CITY OF OPELIKA HISTORIC PRESERVATION COMMISSION

December 11, 2025

City of Opelika
Historic Preservation Commission
Staff Report

Agenda Item #: 2
Meeting Date: 12/11/2025
Action Requested: COA: Renovations to Exterior
Location of Property: 601 S. Railroad Ave; Downtown Historic District
Petitioner: Jake Whaley

Wood steps to be replaced with Hardi

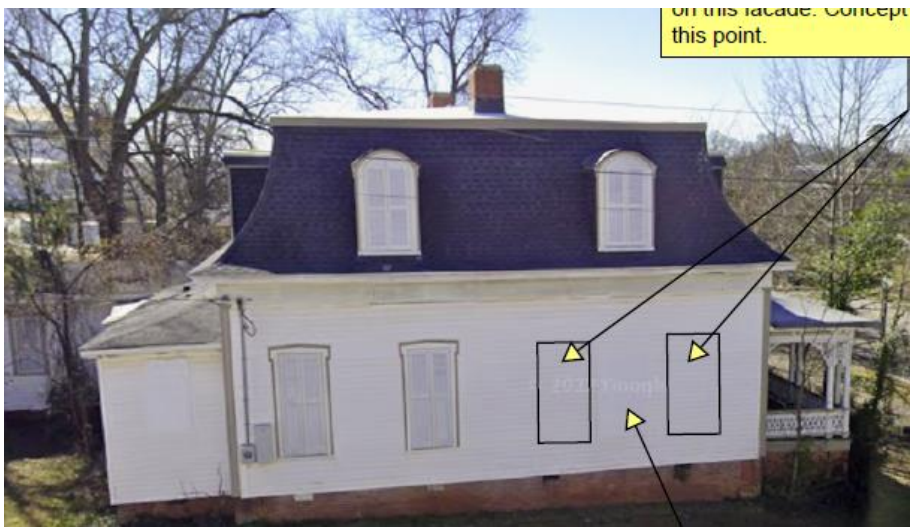
1. Remove vinyl siding and underlying wood siding; replace with smooth surface 4" lap Hardie Plank on main structure and 5" lap on rear addition.
2. Remove tin/wood barricades and enclose crawl space with bricks matching all other brick.

3. Replace rotted wood front steps with Hardi or wood.
4. Remove all landscaping and trees around the foundation and install new plantings to match character of the building.

1. Staff recommends approval of replacing vinyl and wood siding with smooth Hardie Plank. New Hardie siding should have the same profile and reveal as the current wood siding. All architectural details shall be preserved and remain in place.

2. Staff recommends approval of removing tin/wood barricades and enclosing crawl space with brick to match existing brick foundation.
3. Staff recommends approval of replacing wood front steps with Hardi or wood.

Current concrete ramp on rear

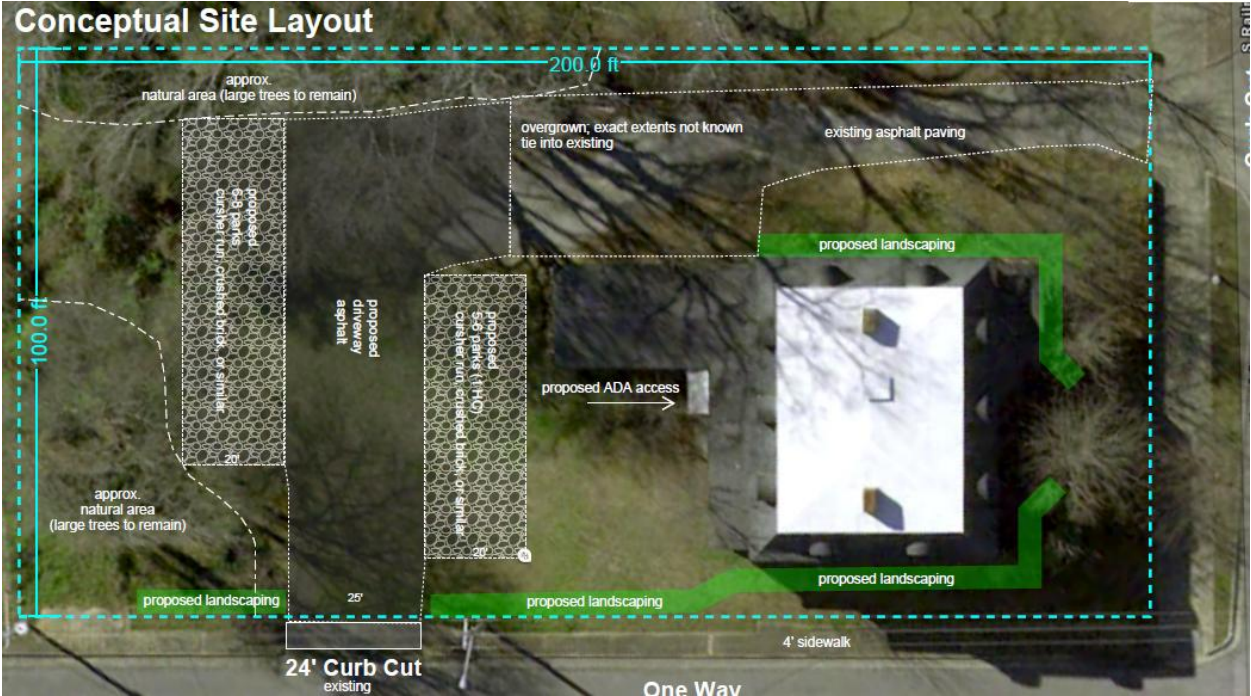
7. Enclose windows on rear to build out restrooms.
8. Install new ADA ramp at existing back door.
9. Install either a widows walk or cupola on rooftop based on historic photos.

7. Staff recommends approval of enclosing rear window (previously a porch) to allow for interior buildout.
8. Staff recommends new ADA ramp meeting code. Applicant to return with design review prior to installation.
